CAUI-4 Ad hoc

Agenda

CAUI-4 chip-module TBDs

Figure 83A-8—Transmitter eye mask

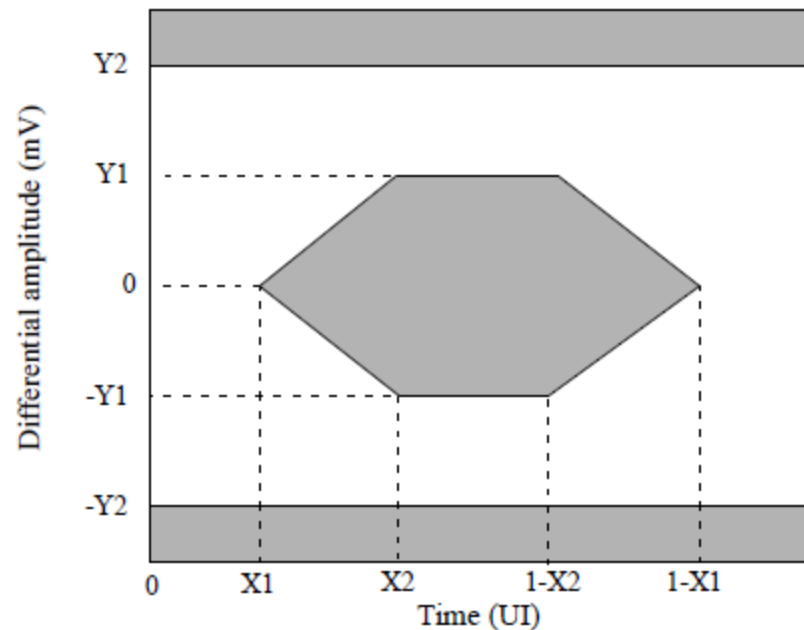
Output Waveform

Transmitter mask definition X1:

Transmitter mask definition X2:

Transmitter mask definition Y1:

Transmitter mask definition Y2:

Figure 93–7—Transmit equalizer functional model

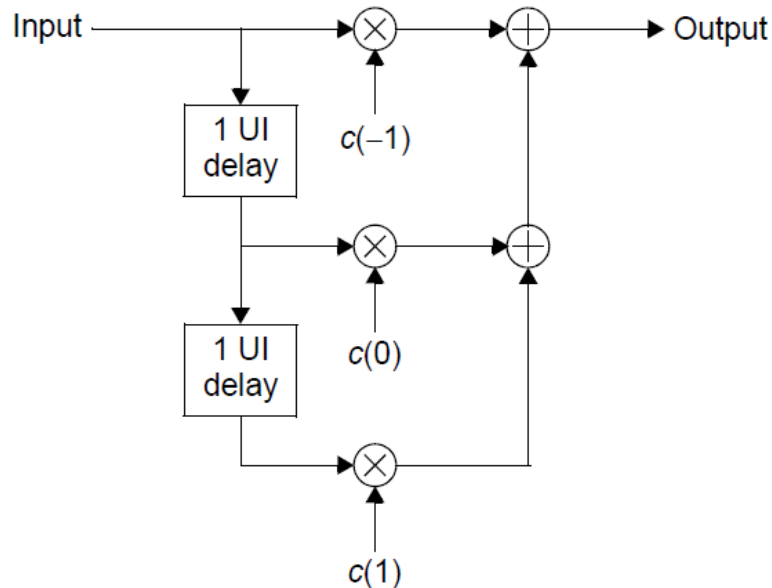
Define ON state using functional model, specify single dB setting, with recommendation for use on channels $>$ TBD dB insertion loss
